The Town of Hilton Head Island Regular Design Review Board Meeting

AGENDA

The Town of Hilton Head Island
DESIGN REVIEW BOARD
Minutes of the Tuesday, March 22, 2011 Meeting
1:15pm – Benjamin M. Racusin Council Chambers

Sheet Title:
Planting Plan

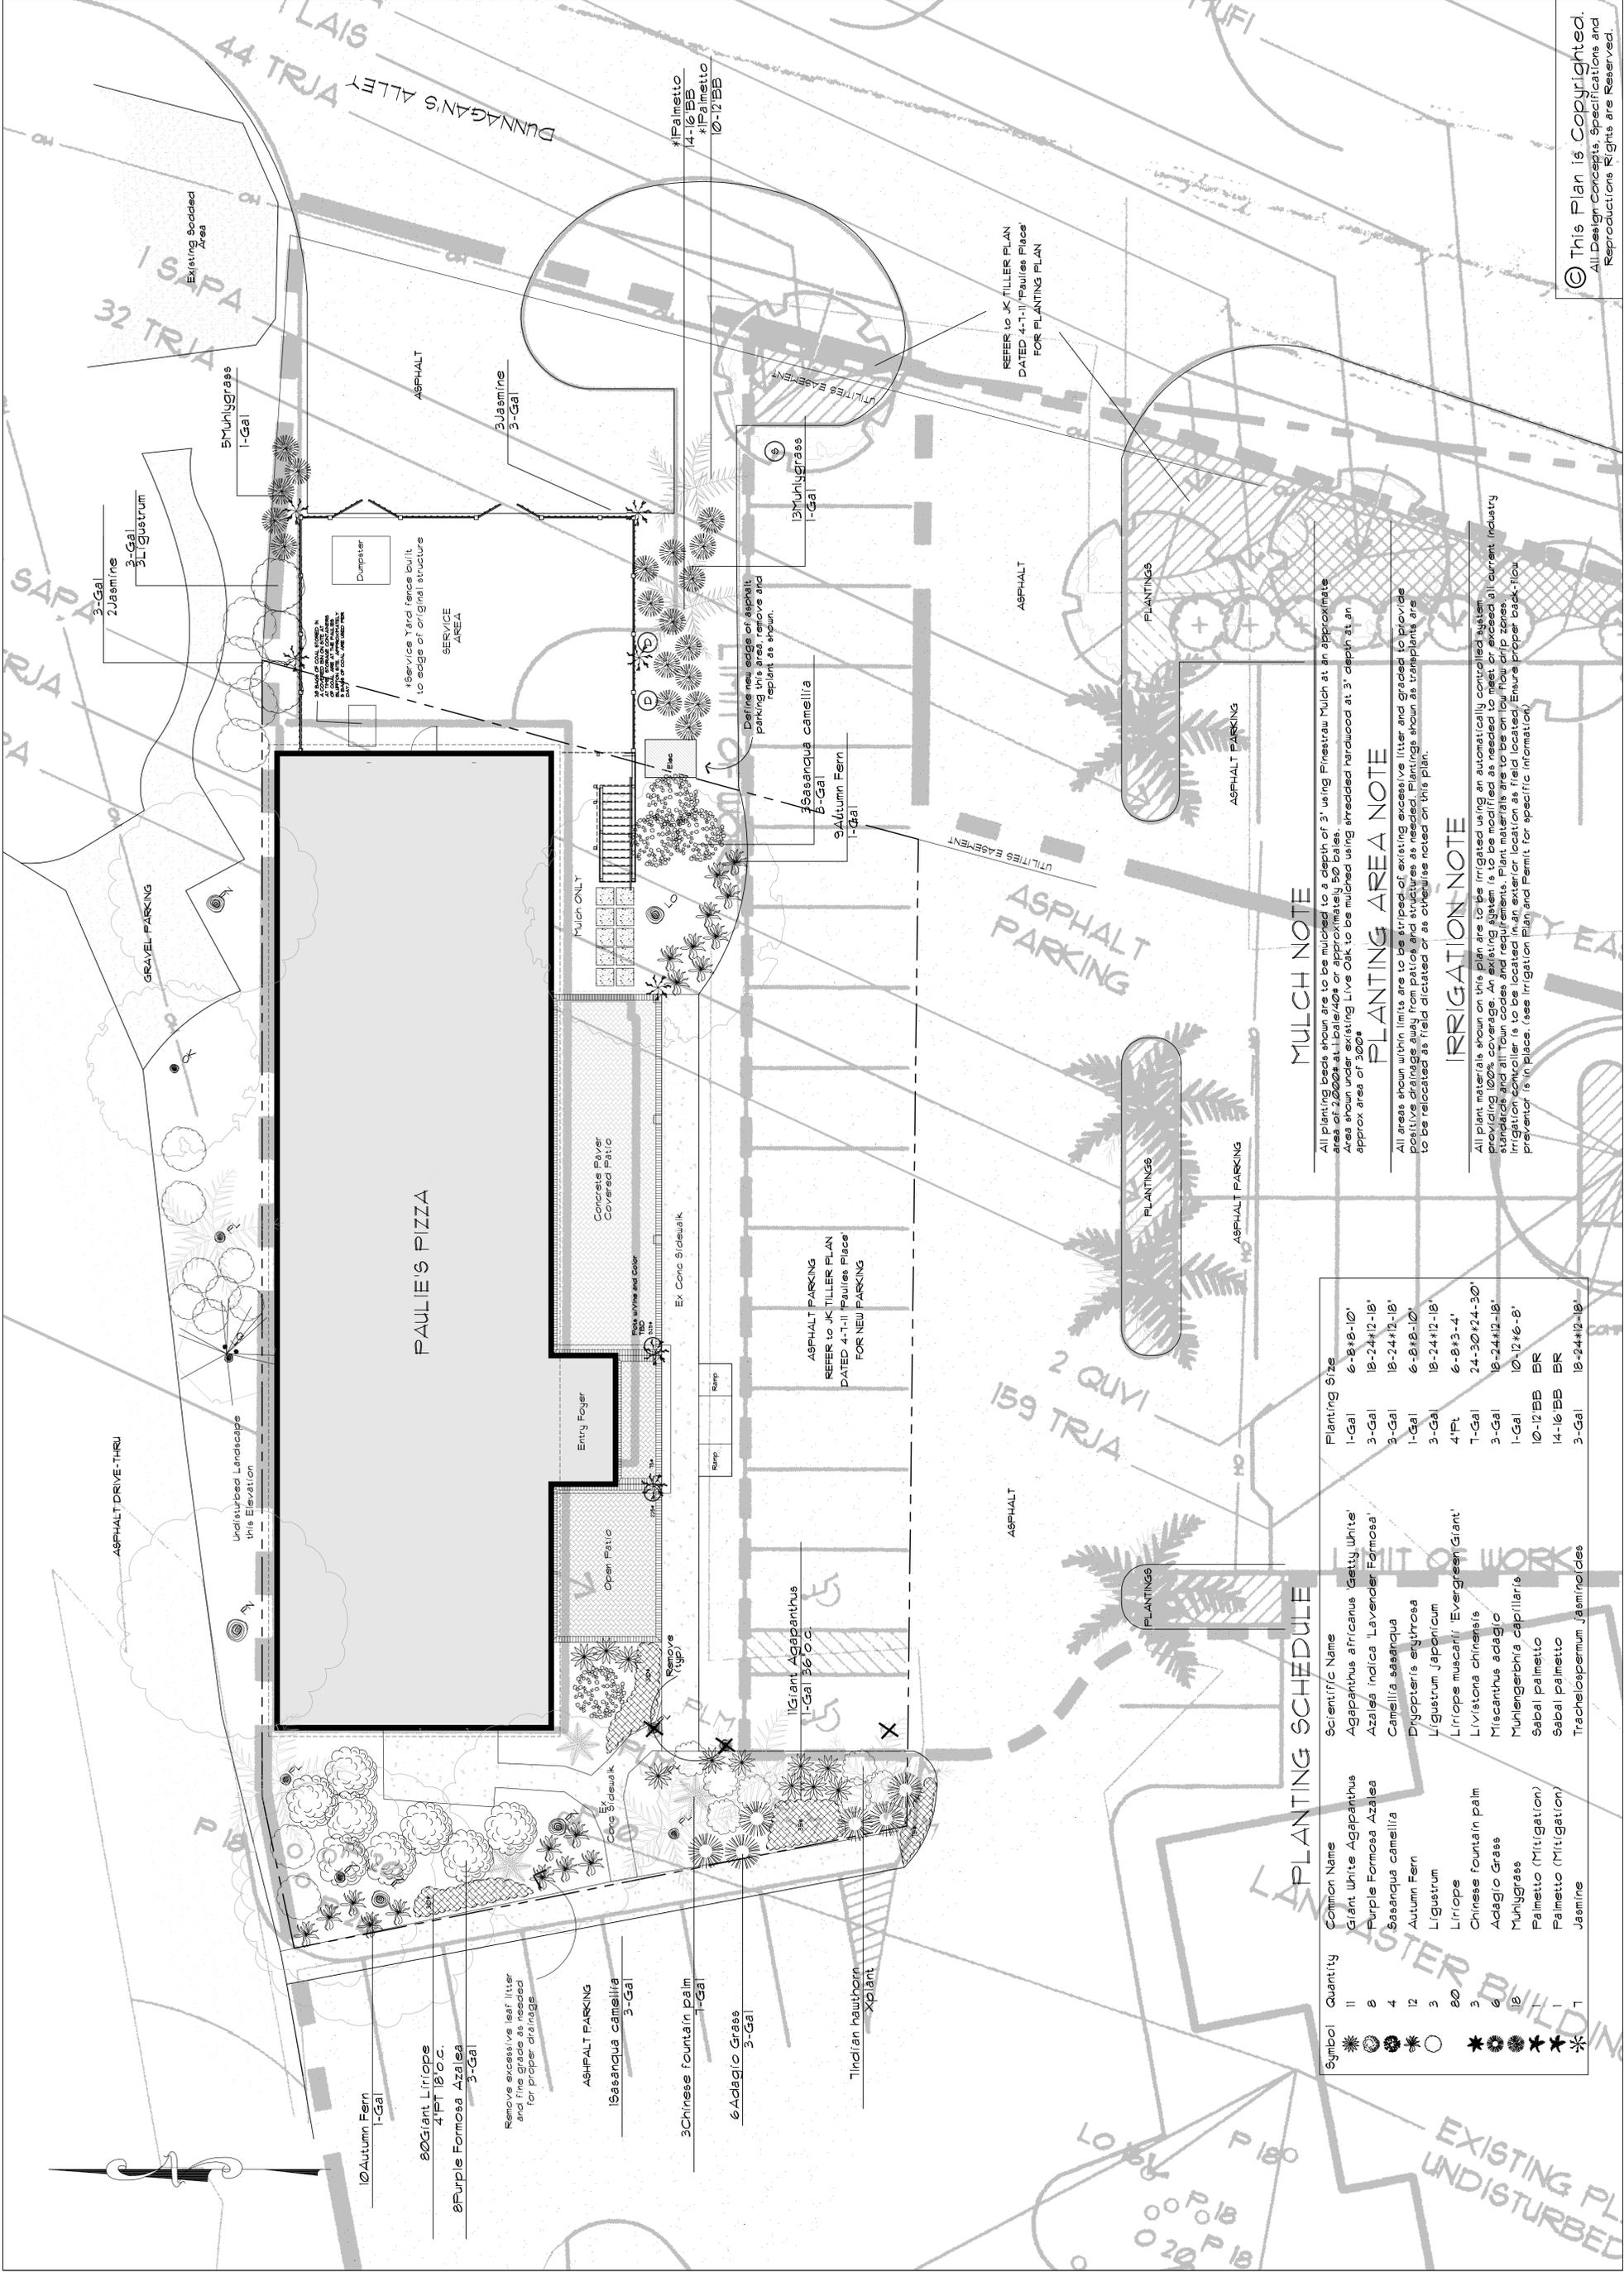
DESIGN GUIDE/LMO CRITERIA	COMPLIES YES/NO/NA	COMMENTS OR CONDITIONS
Treats the Landscape as a major element of the project	Y	
Provides Landscaping of a scope and size that is in proportion to the scale of the development	Y/N	All foundation planting in the form of shrubs should be 7 gal. minimum
Landscape is designed so that it may be maintained in its natural shape and size	Y	
Preserves a variety of existing native trees and shrubs	Y	
Provides for a harmonious setting for the site's structures, parking areas or other construction	Y	
Location of existing trees and new trees provides street buffers, mitigation for parking lots, and an architectural complement that visually mitigates between parking lots and building(s)	Y/N	
Shrubs are selected to complement the natural setting, provide visual interest and screen less desirable elements of the project	Y/N	Median at the hammerhead for turn-around at the service yard should be planted to screen from the street

A variety of species is selected for texture and color	Y	Palette has maybe too much variety, and should be consolidated to materials already selected in the schedule
Provides overall order and continuity of the Landscape plan	Y/N	See comment above
Native plants or plants that have historically been prevalent on the Island are utilized	Y	
A variety of sizes is selected to create a “layered” appearance for visual interest and a sense of depth	Y	
The location of existing mature trees is taken into account in placement of shrubs so as not to damage tree roots	Y	
Proper spacing and location for plants to reach their mature size and natural shape while avoiding excessive or unnatural pruning	Y	
Proposed groundcovers are evergreen species with low maintenance needs	Y	Agapanthus has durability issues, and might serve the consolidation notion by substituting
Large grassed lawn areas encompassing a major portion of the site are avoided	Y

DESIGN GUIDE/LMO CRITERIA	COMPLIES YES/NO/NA	COMMENTS OR CONDITIONS
An effort has been made to preserve existing trees and under story plants		There is a lot going on under the large live oak at the front of the building, and the tree has had impacts to it during construction. Please remove the stepping stones and move the camellias outside the tree’s dripline. The applicant should consider using more native plants; currently there are only autumn fern and muhly grass.
Supplemental and replacement trees meet LMO requirements for size, species and number		
Wetlands if present are avoided and the required buffers are maintained		
Sand dunes if present are not disturbed
